SYSTEM: ADVANCED LIGO SUB-SYSTEM: AOS

PART NAME		DESIGNER		DATE	SIZE	DWG. NO.	REV.
SLC EDDY CURRENT DAMPING 8 DIA TUBE ASSY		N.Nguyen		01 Jun 2010	D	D1002564	v4
DRAFTER		N.Nguyen		24 AUG 2010			
CHECKER		M. Smith		01 NOV 2010			
APPROVAL		D. Coyne		10 NOV 2010	SCALE: 1:2	PROJECTION:	SHEET 1 OF 2

GENERAL VIEW

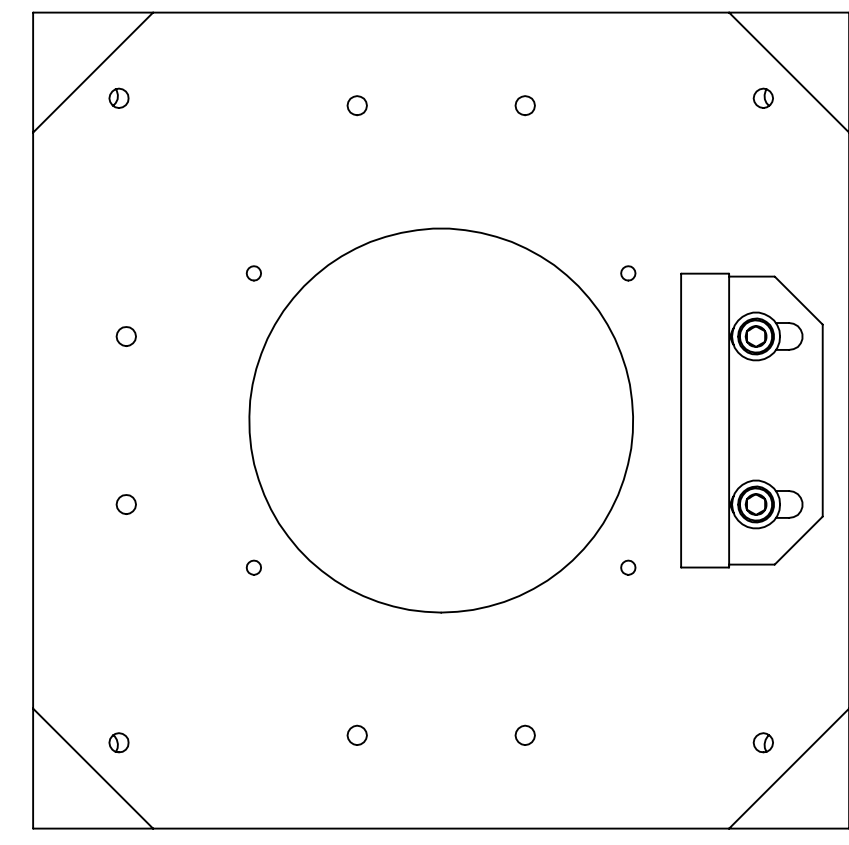
Drawing needs update -
1) Copper Plate modification
2) Add V1156 2-116 O-rings, qty = 2
